To: Ken Johnson, Delaware Engineering
From: McKownville Improvement Association (Martha Harausz, Don Reeb, and Jim White)
Subject: Parking lot Proposed by Stuyvesant Plaza
Date: April 1, 2013

New Parking Area:

Tax Map:

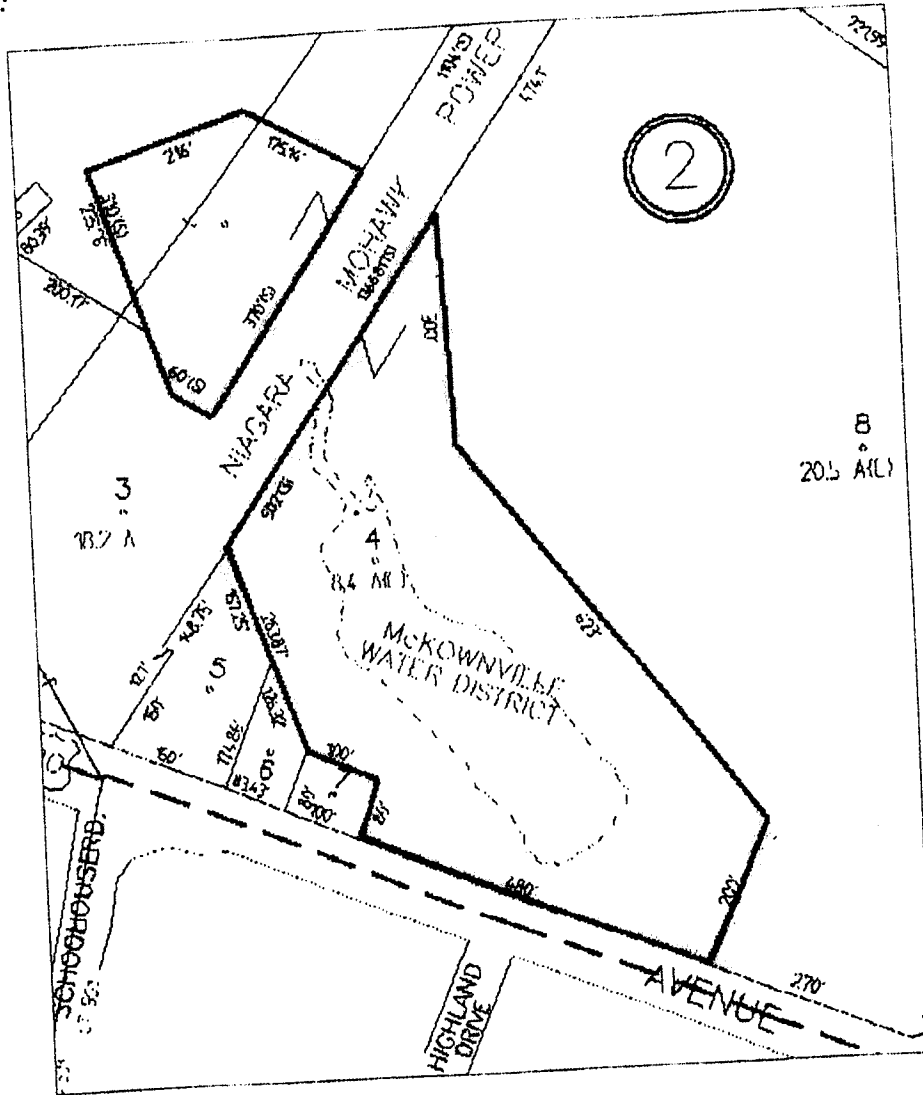
→ Joseph show aspects of West end only - map
